Technical Note

Project:	P16-530 Land at Newark Road, Sutton-in-Ashfield		
Subject:	Technical Note – Flooding and Drainage		
Prepared by:	Matthew Leask – Associate	Date:	6 January 2025
Authorised by:	Kriston Harvey - Director	Status:	S2 - Information
Document Ref:	16530-RLL-24-XX-TN-C-0003	Revision:	P03

This note has been prepared in response to a statement provided by Councillor Matthew Relf, which was issued to the appellant by email on 17th December 2024.

Figure 1: EA Surface Water Flood Extents

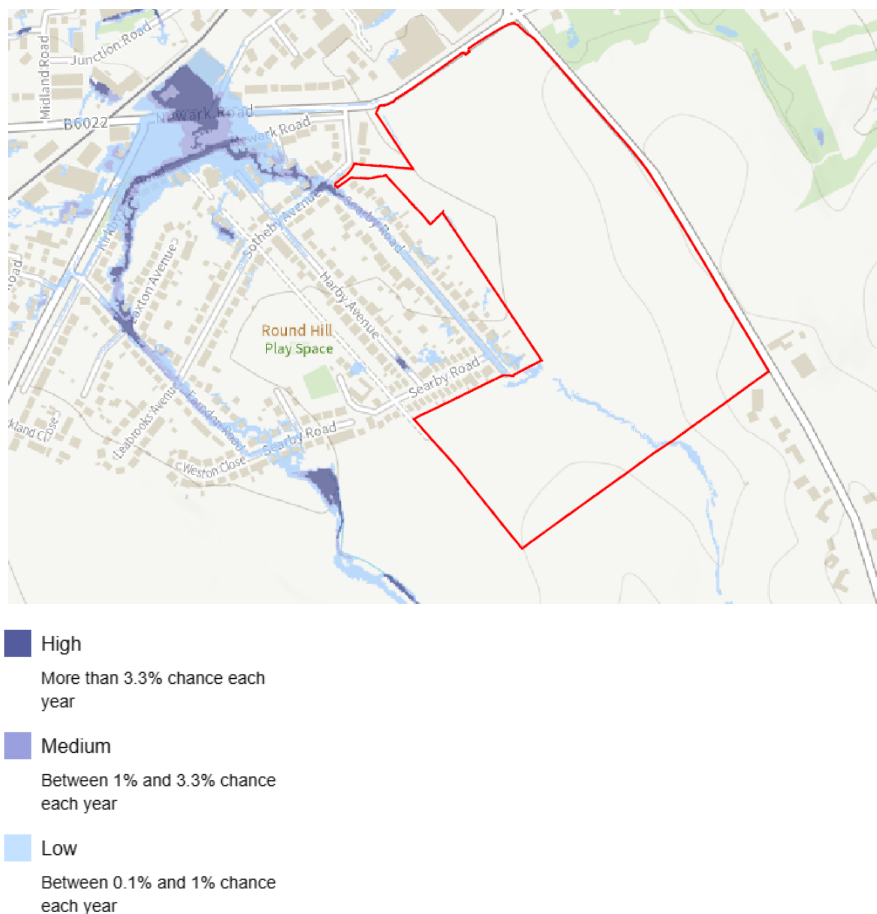
Cllr Relf expresses concerns that the Site is impacted by surface water and ground water flooding and that the application does not adequately take this into account. The statement identifies an overland flow path that runs from the southern boundary to the apex of the inverted ‘L’ shape of the site (referred to as “the Site”). Cllr Relf attributes the flows to a watercourse that runs from the ditch immediately south of the Site, and then across the Site, that he says becomes overwhelmed during periods of heavy rain. The statement includes a photo of a channel within the Site, which is taken at a point adjacent the back gardens of properties on Searby Road in the approximate location of the

proposed SUDs basins. Cllr Relf raises concerns that the layout does not take into consideration this overland flow path.

At section 3.1.3, the FRA confirms that, following a review of Environment Agency (EA) online flood mapping, there are areas within the Site shown to be at 'Low' risk of surface water flooding. This is shown to have a chance of flooding of between 1 in 1000 (0.1%) and 1 in 100 (1%). The EA Long Term Flood Risk Surface Water Flood maps were reviewed on 11th December 2024 and an extract of the map with the Site red line boundary added, is shown at Figure 1. Only Low risk surface water flooding is shown within the Site boundary. The map shows a thin sliver of Low risk surface water flooding within the area of the flow path identified by Cllr Relf.
